THE CLEVELAND ELECTRIC ILLUMINATING COMPANY

April 29, 1985
PY-CEI/NRR-0207L

Perry Nuclear Power Plant
Docket Nos. 50-440; 50-441
Response to Additional Staff
Questions Pertaining to the
PNPP Initial Test Program

Figure 14.2-7

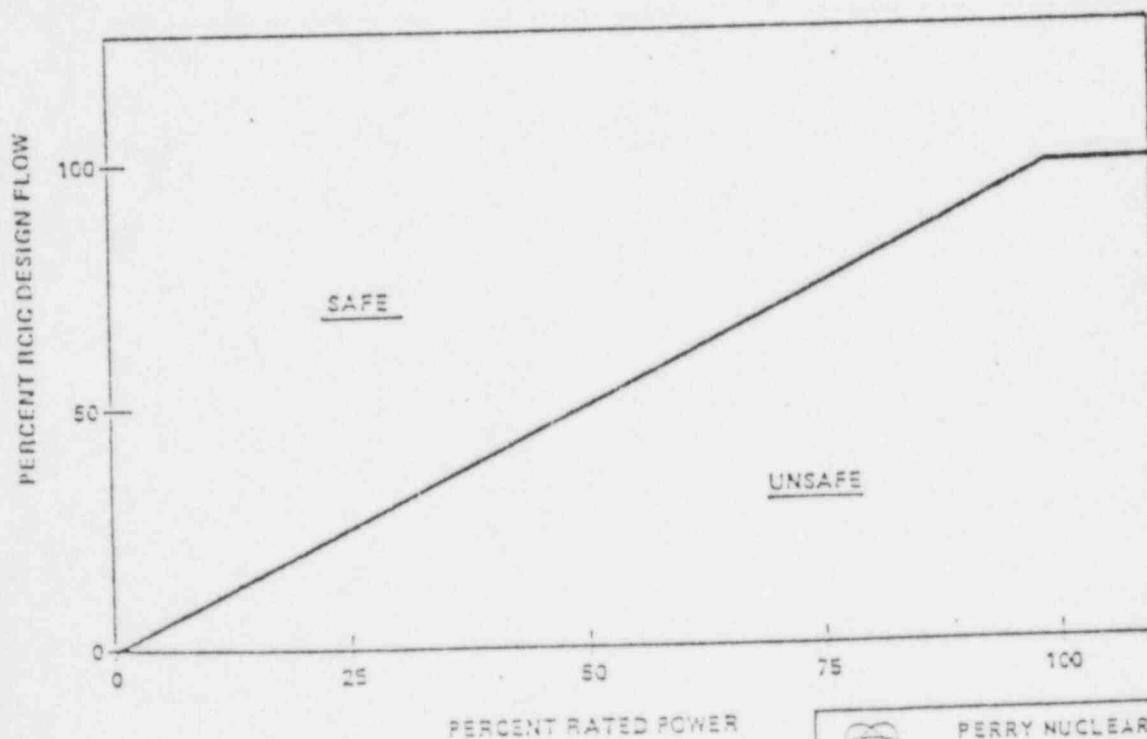
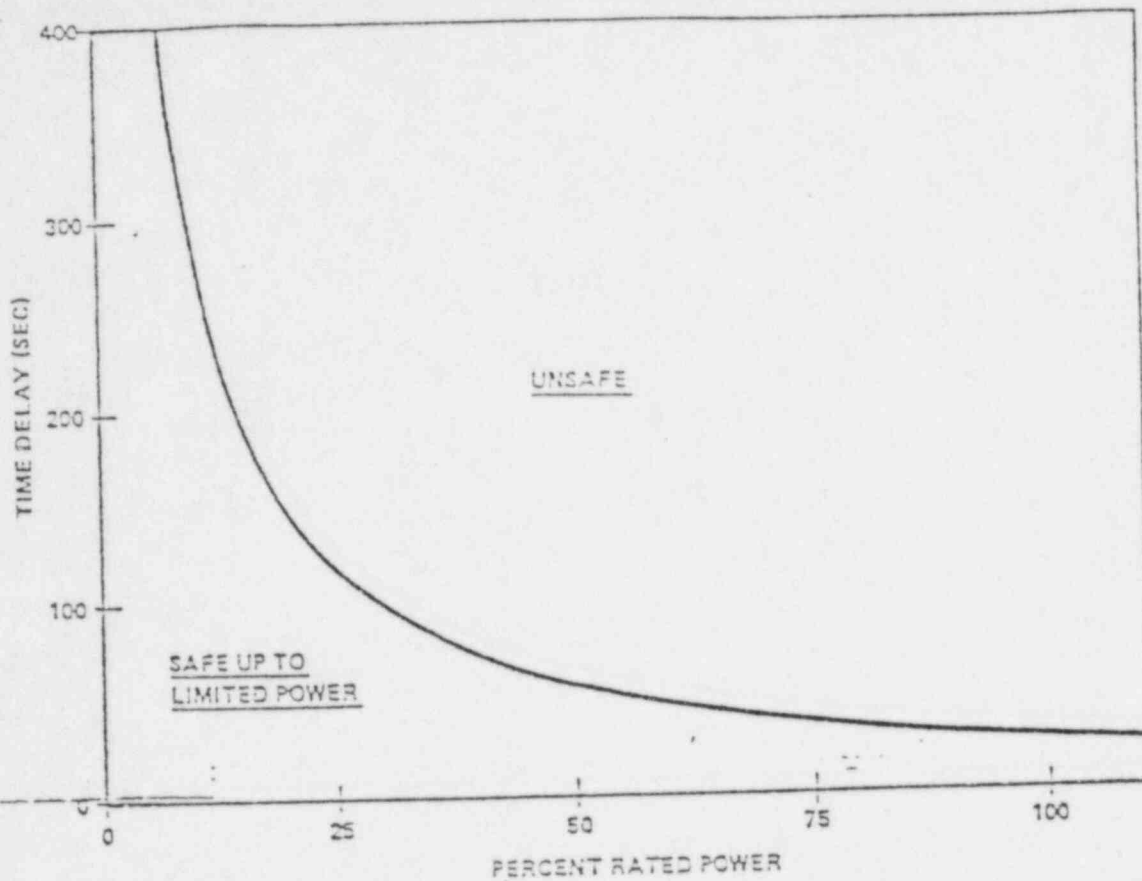
- (2) The RCIC System Test (FSAR Subsection 14.2.12.2.12) Level 1 acceptance criteria should clarify reference to Figure 4.2-7. If this reference should be Figure 14.2-7, then this figure should be reinstated.

- (2) Section 14.2.12.2.12 should reference Figure 14.2-7, which has been reinstated.
- (3) The Water Level Reference Leg Temperature Test (FSAR 14.2.12.2.13.1) does not include an acceptance criteria for the Fuel Range because it is not practical to obtain the assumed calibration conditions (Post-accident conditions in the drywell and containment) for this range, as it is detrimental to equipment. The Water Level Reference Leg Temperature Test (FSAR 14.2.12.2.13.1) Level 2 acceptance criteria was revised in Amendment 16 to the FSAR (attached) to include all other ranges.
